USNRDL-TR-582
17 September 1962

DESIGN MODIFICATIONS AND 1962 COST ANALYSIS
FOR A STANDARDIZED SERIES OF FALLOUT SHEILDERS

prepared for the
OFFICE OF CIVIL DEFENSE
DEPARTMENT OF DEFENSE

U. S. NAVAL RADIOLOGICAL DEFENSE LABORATORY
S A N F R A N C I S C O 2 4 . C A L I F O R N I A

ARRANGEMENT 'A' ELECT. PACKAGE

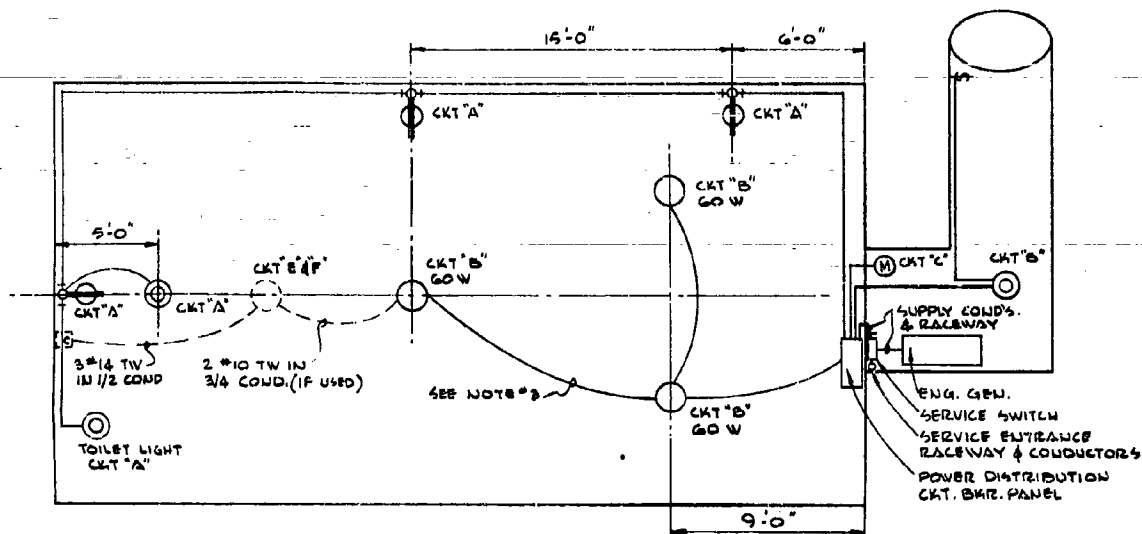
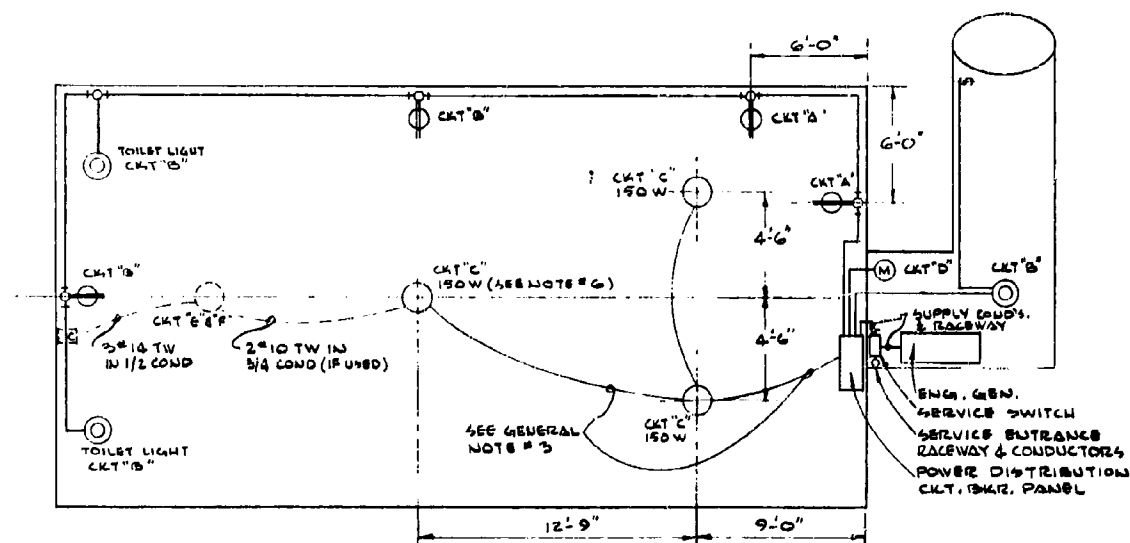
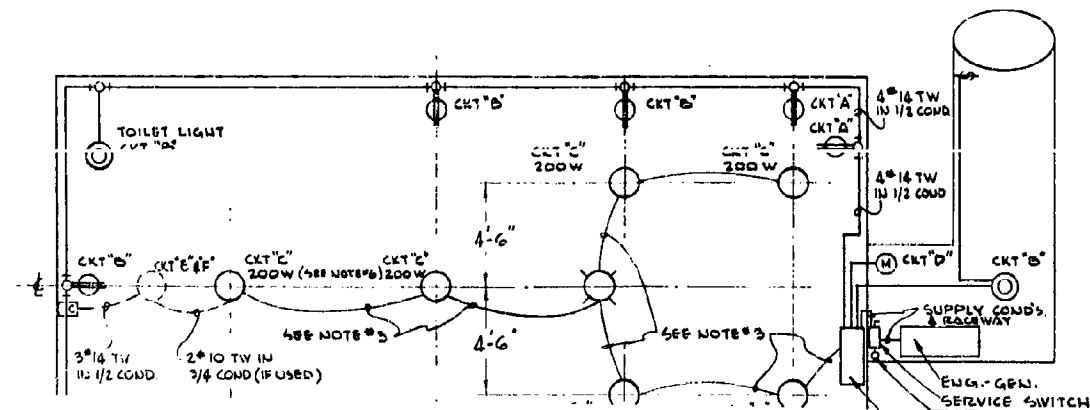
The design of the electrical lighting and power system of Ref. 1 has been modified as shown in Fig. A-12N. The design was dependent on the maximum electrical load that would result when the electric equipment specified in the various shelter packages were energized. Governing equipment were lighting, control equipment, food immersion heater, hot plate, vent fan, and air conditioner. A study of the probable combination

of the shelter packages indicated the need for three separate electrical lighting and power distribution systems, as shown in detail on Fig. A-12N as Arrangement A, Arrangement B, and Arrangement C.

FIG. A-17M

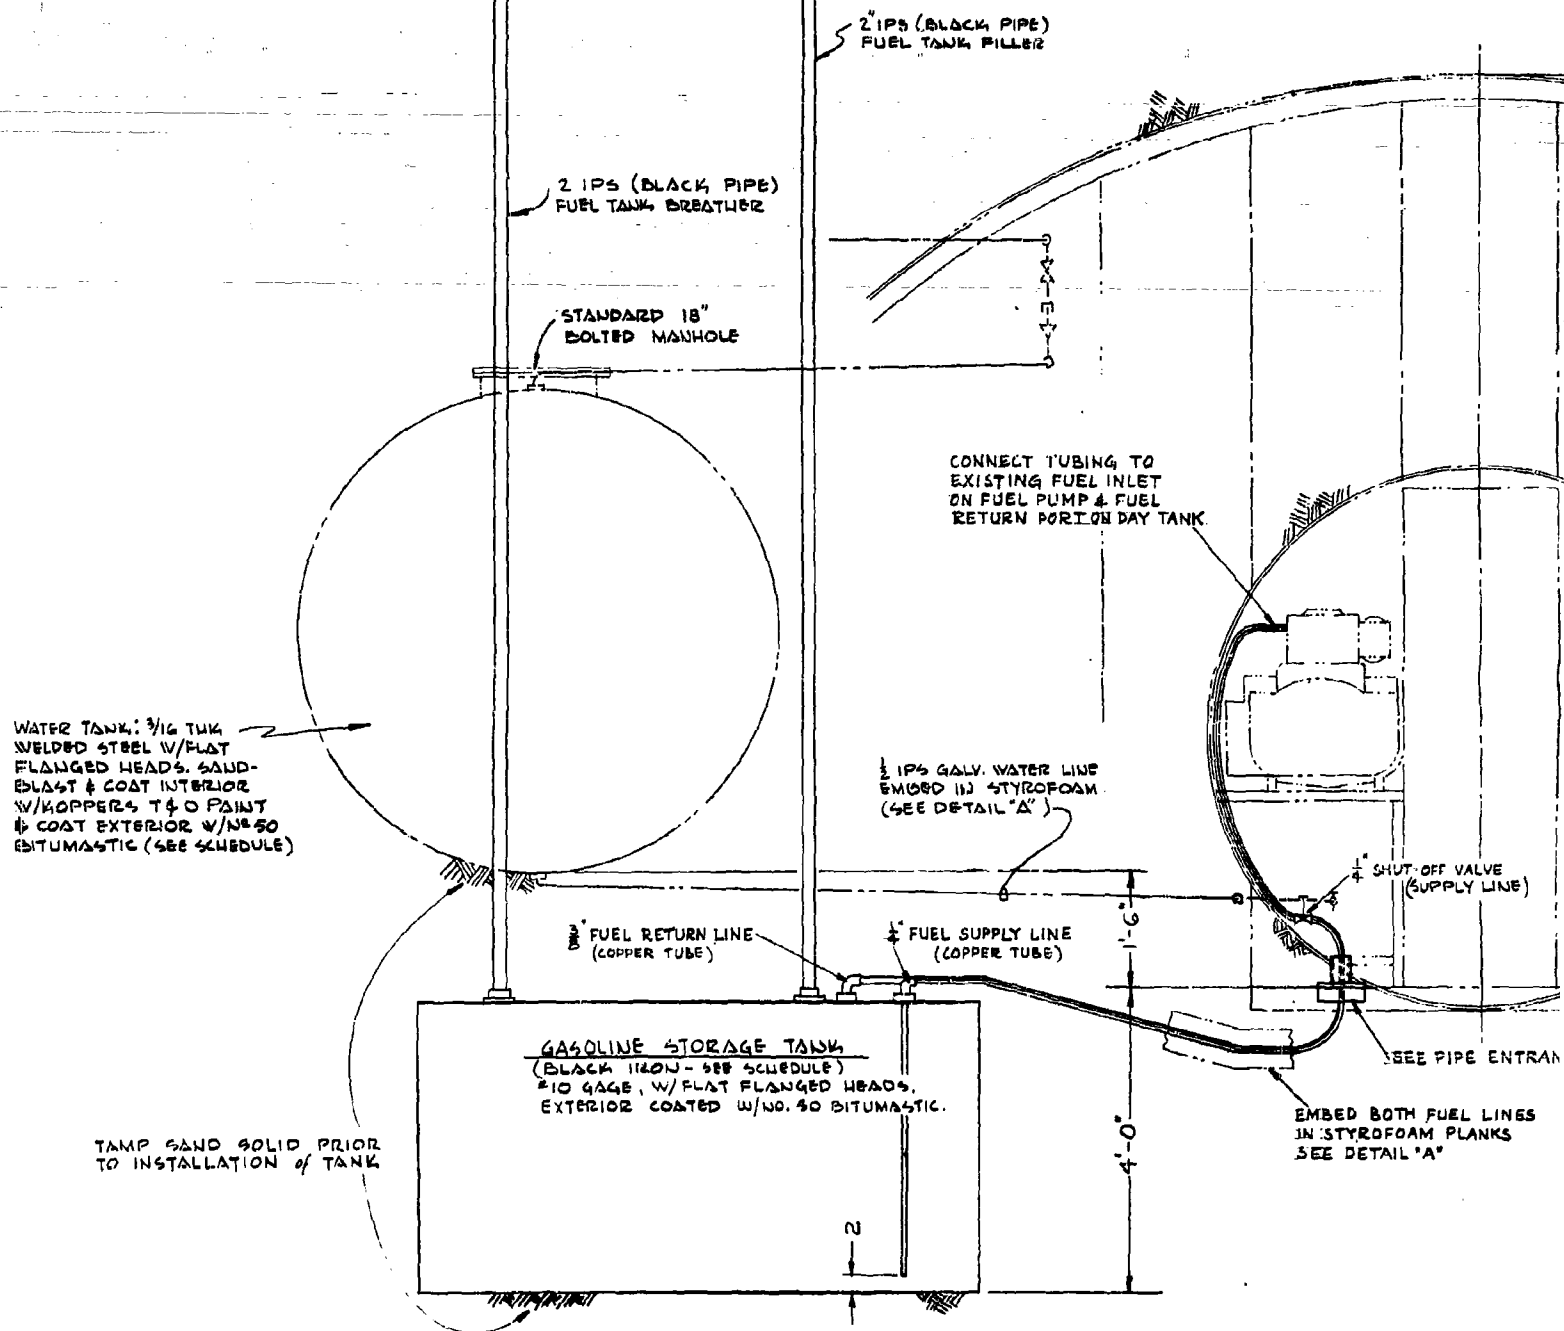
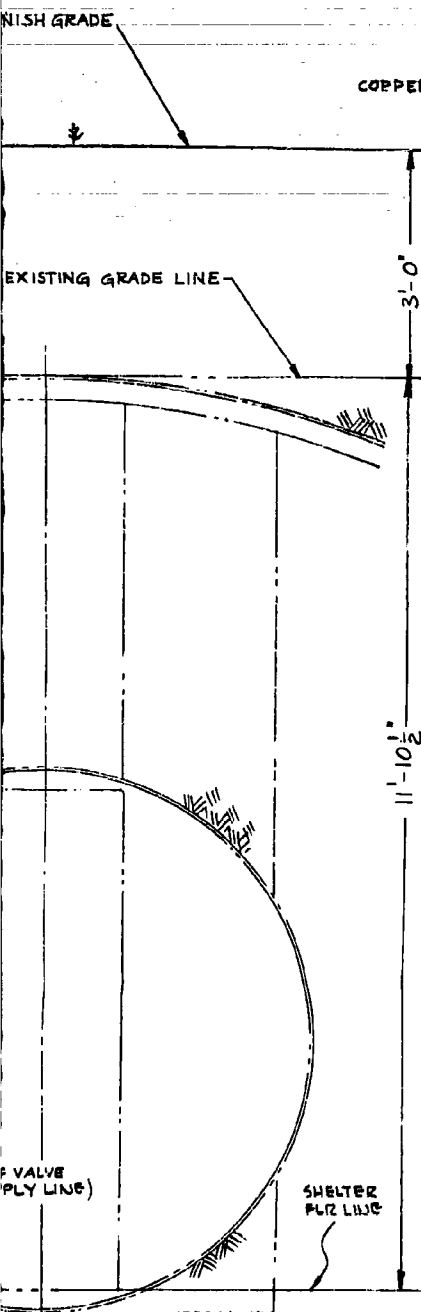
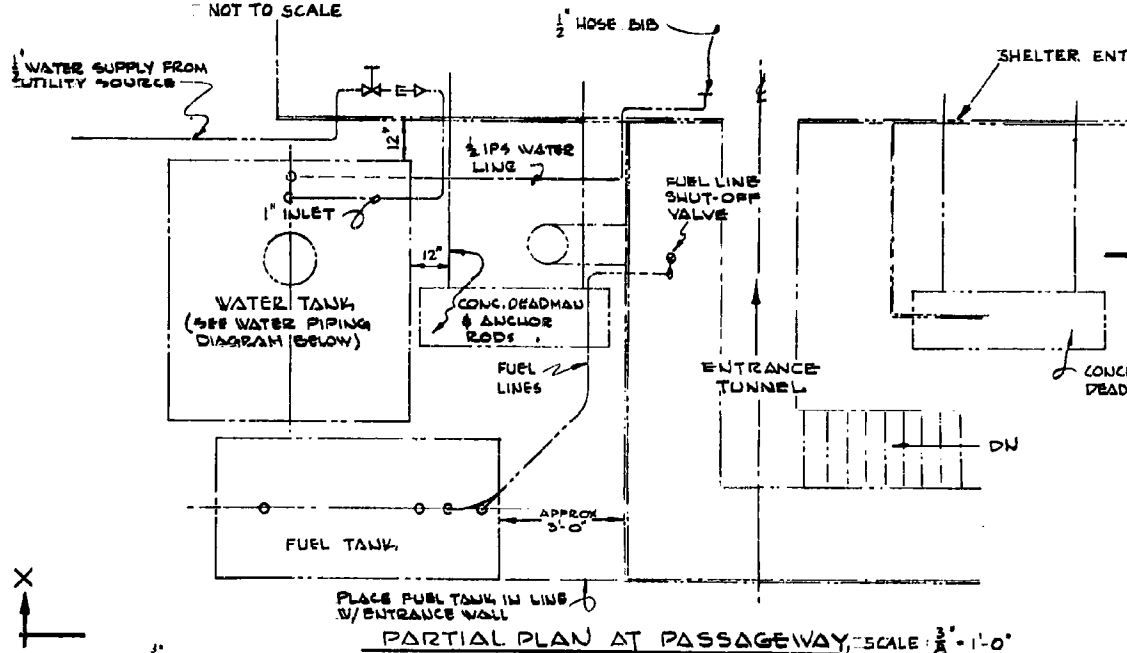
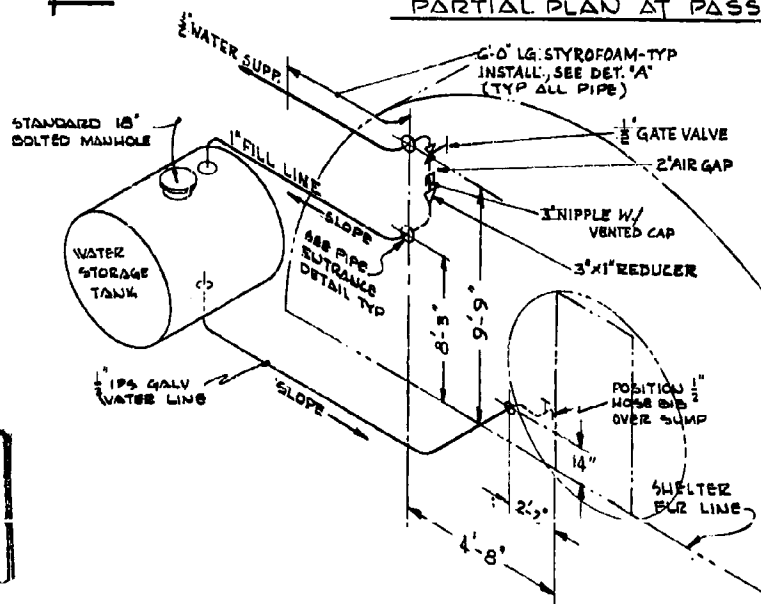
The design of these tanks has been modified to decrease their cost without affecting their performance in the intended environment. See Figs. A-11M and A-17M.

The design of these systems has been modified to decrease the possibility of the water and fuel piping connections breaking at their point of entry to the shelter during the positive blast pulse. See Fig. A-7M.

The fuel tanks have been modified to get more efficient use out of the basic sheet metal stock as "provided to the fabricator by the steel manufacturer." Also, the dished tank heads specified in Ref. 1 have been replaced by flat, flanged tank heads. Both changes will result in considerable savings in tank costs.
